PPP Social Housing Bundle 3:
Development at Athy, Co. Kildare
Stage 1&2 Road Safety Audit

Stage 1&2 Road Safety Audit

| Drawing No. | Drawing Title | Revision |
|-------------------------|--------------------|----------|
| SHB3-ATY-AR-COA-SK-0001 | Proposed Site Plan | A |

Figure 2.1 – Pedestrian Crossing at Main Access Junction

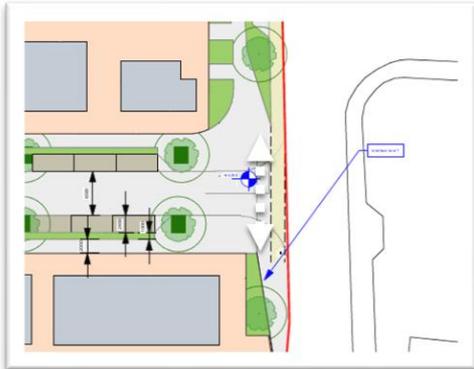
2.1 Problem: Pedestrian Priority at Access

Location: Main Direct Access Junction onto Fortbarrington Road

Measures to afford priority and safe crossing for pedestrians do not appear to have been proposed at the new access junction. This could lead to conflicts between pedestrians and vehicles.

Measures to afford both priority and safe crossing for pedestrians should be provided at the location described.

| Problem Reference (Section 2) | Designer Response Section | | | Audit Team Response Section |
|-------------------------------|-----------------------------|---|---|--|
| 2.1 | Yes | Yes | | |

Figure 2.2 – Northern Termination of Proposed Footpath

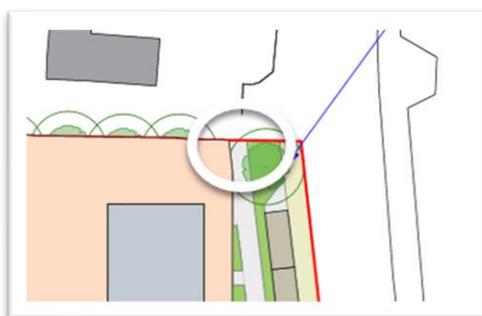
2.2 Problem: Footpath Termination & Connection

Location: Site Frontage onto Fortbarrington Road, Northern Boundary Termination

The proposed footpath both directs pedestrians towards and terminates at an existing dwelling access. This could lead to pedestrians (in particular the mobility impaired) coming into conflict with traffic as they attempt to cross the road to re-join the safety of a footpath which continues on the opposite side of the road.

The footpath termination should be moved away from the dwelling access and a formal crossing connection should be provided to the footpaths on the opposite side of the road.

| Problem Reference (Section 2) | Designer Response Section | | | Audit Team Response Section |
|-------------------------------|-----------------------------|---|---|--|
| 2.2 | Yes | Yes | A pedestrian crossing is proposed at this location for review and approval by Kildare County Council. | <i>Noted with thanks</i> |

Figure 2.3 – Southern Connection of Proposed Footpath

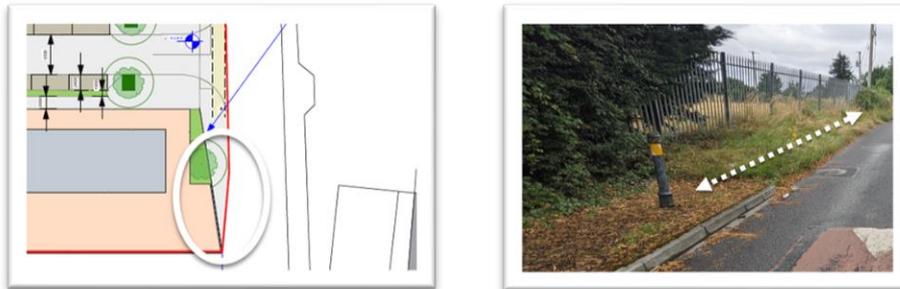
2.3 Problem: Footpath Termination & Connection

Location: Site Frontage onto Fortbarrington Road, Southern Boundary Termination

A tapered footpath termination has been proposed without safe connection for pedestrians to existing footpaths further to the south in front of the Halting Site. This could lead to pedestrians (in particular the mobility impaired) being forced to walk in the carriageway with general traffic.

The tapered termination should be replaced with a footpath of continuous (and appropriate) width which connects to the existing footpath facilities in front of the Halting Site.

| Problem Reference (Section 2) | Designer Response Section | | | Audit Team Response Section |
|-------------------------------|-----------------------------|---|---|--|
| 2.3 | Yes | Yes | | |
